APPROVALS	DATE	TITLE			
TECH PUB Bill Patt	2/2/00	WULFSBERG SERVICE BULLETIN WSB C-962N-2 (MAKES THE TONE OUTPUT MORE UNIFORM)			
CHECKED Cliff Estes	1/14/00				
ENGINEER Hank Schnieder	2/2/00	SIZE A	CAGE CODE 1B7G3	DWG. NO. 150-040549	REV A
ISSUED Vern Wallace	2/3/00	SCALE NONE

SERVICE BULLETIN

BULLETIN NUMBER: WSB C-962N-2

This Service Bulletin describes the procedure required to modify the C-962N CPU/Display Board.

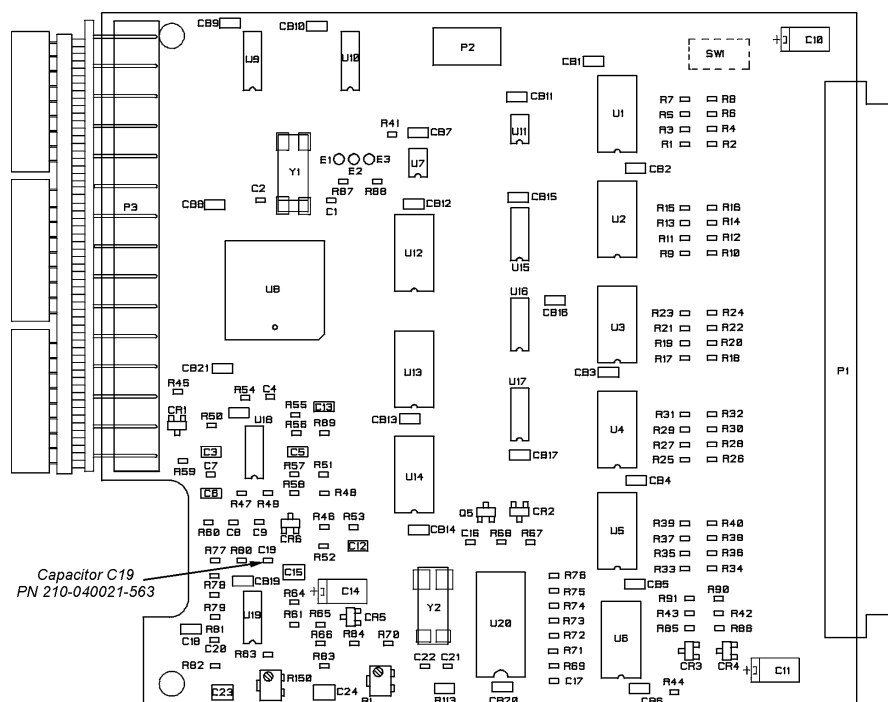
2. Remove and replace Capacitor C19 with Capacitor, .056 μ f 10% 50V, PN 210-040021-563.
